# County of Fairfax, Virginia

## STAFF REPORT

### RZ/FDP 2011-PR-017

**PROPOSAL:** RZ 2011-PR-017: To rezone four parcels to the Planned Tysons Corner Urban District (PTC District) for a mixed-use development consisting of seven multi-family residential buildings ranging up to 245 feet in height, with up to 50,000 square feet of ground floor retail/commercial uses.

C-9

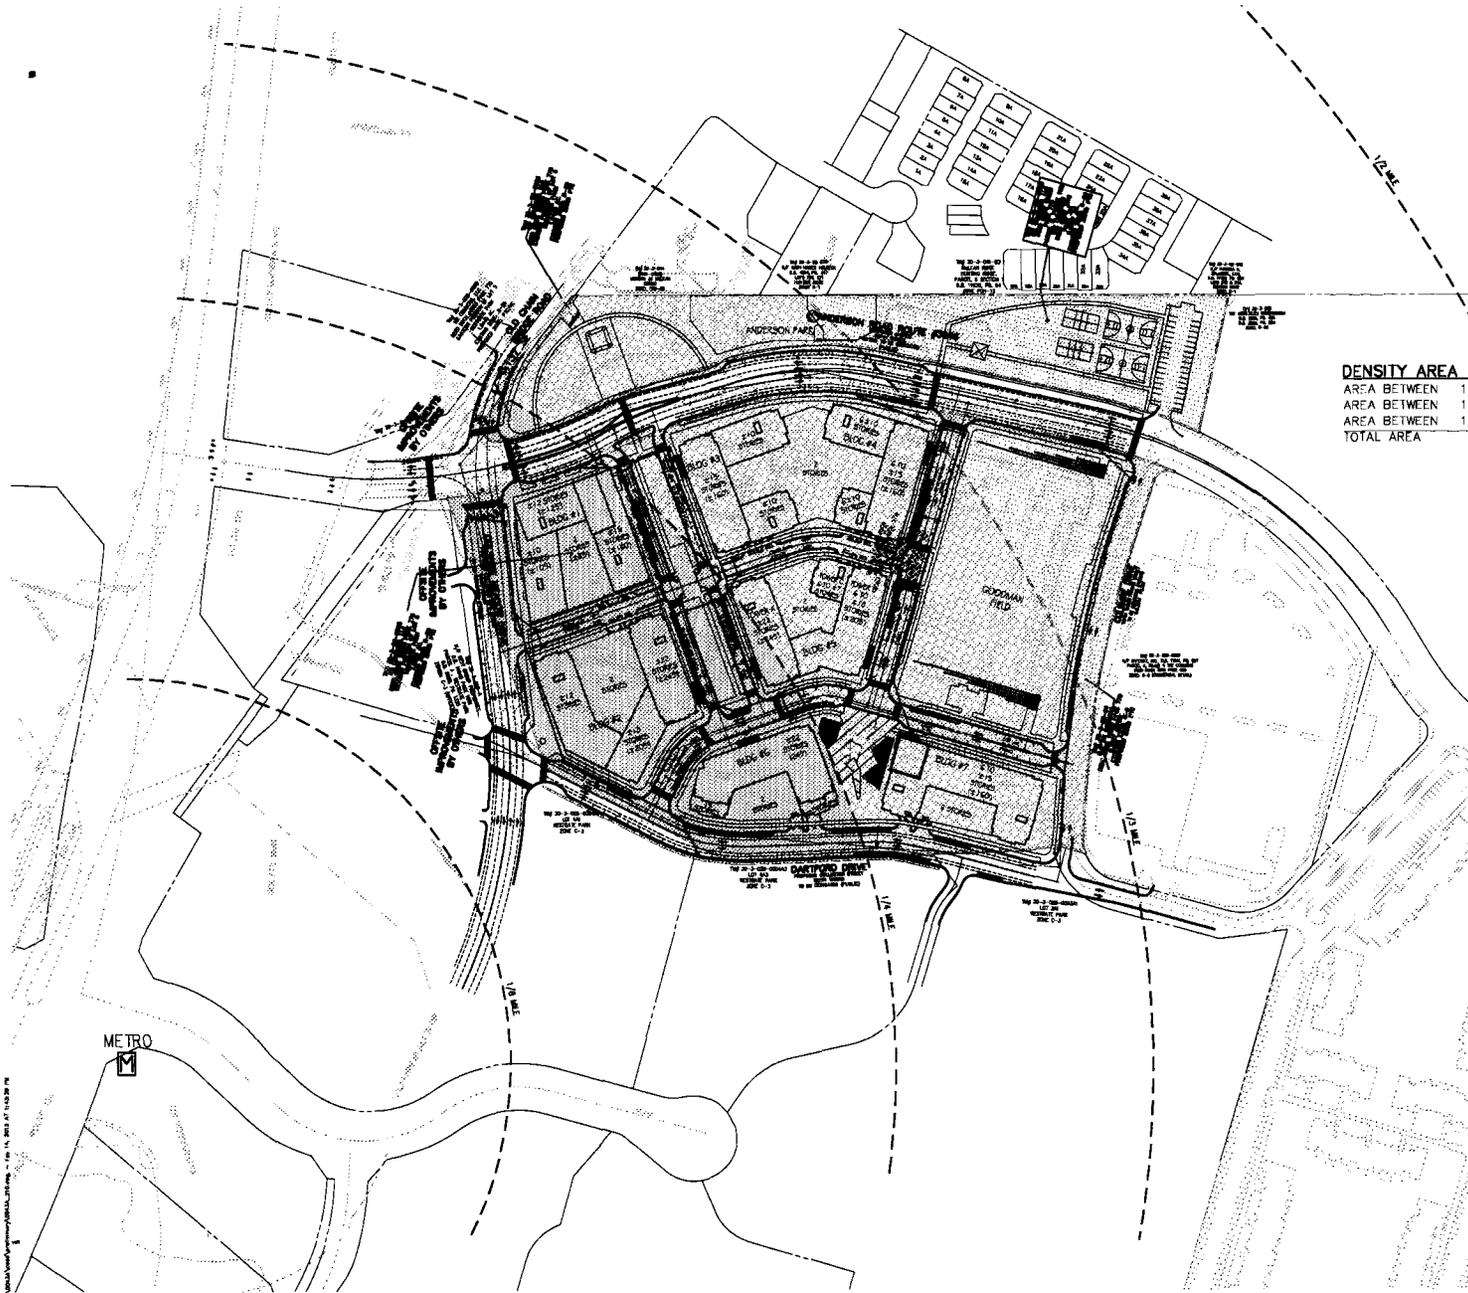
**Recommendation:** The Tree Preservation Target Calculations and Statement tables on sheet C-10 and the Tree Cover Calculations on sheet L-16 should be revised to identify the accurate amount of total canopy area provided through tree preservation. In addition, the

Scale  
**A.12**

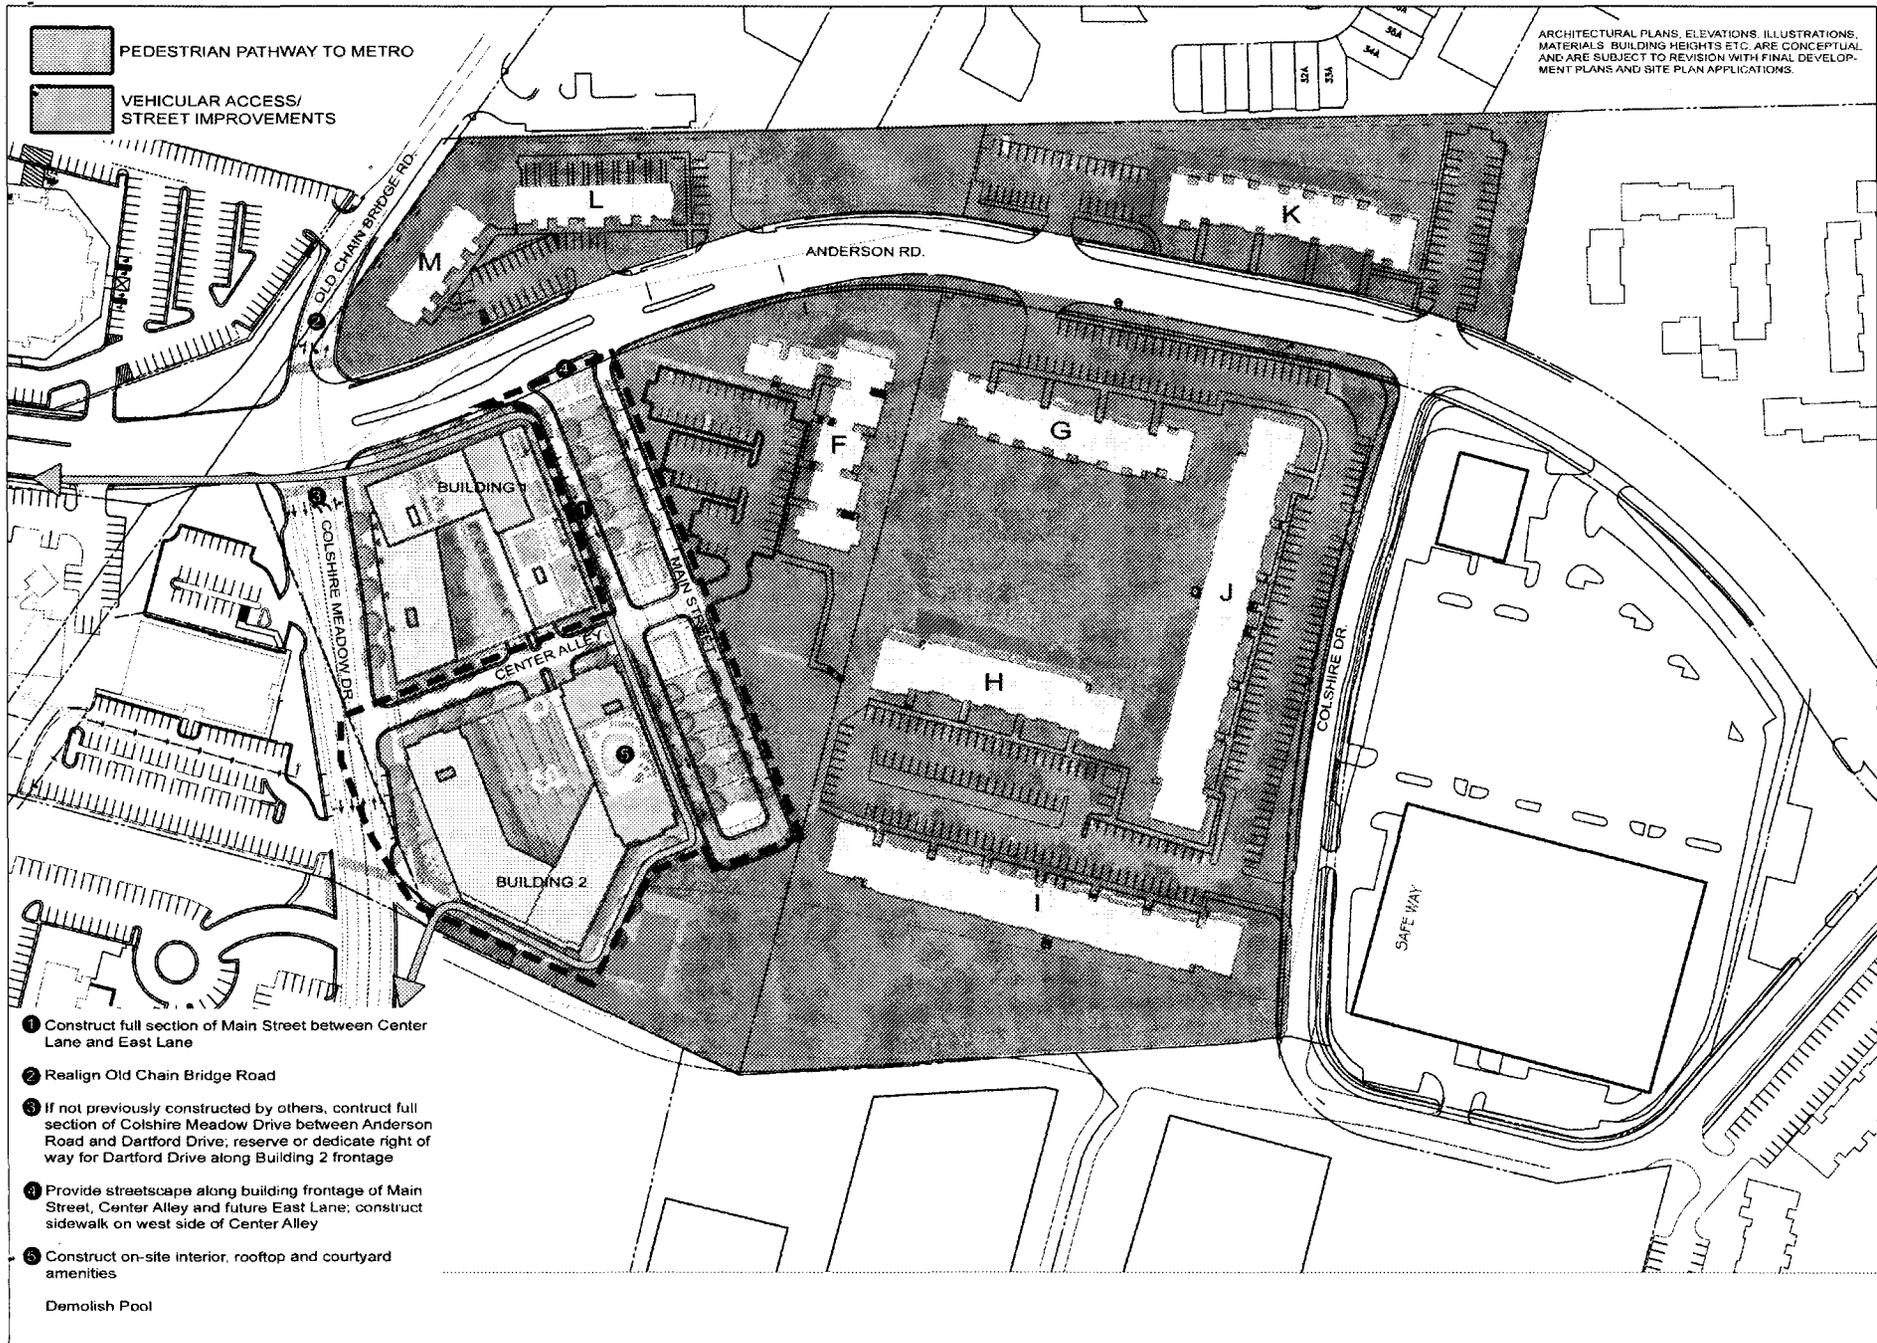
- c. The FDP identifies interim sidewalk improvements within the interim landscaping area. These sidewalk connections should be identified on Sheet A.12.

- a. The CDP Phasing Plan for Building 1 (Sheet A.12) does not contain any details for the interim landscaping, located in the future Building 2 area, with the Building 1 improvement. This area is located outside of the proposed Building 1 FDP area. Improvements are shown on the Site Landscape Plan (Sheet L-3) including removal of existing structures, significant grading, creation 'interim lawn space', interim sidewalk improvements, and interpretive elements.
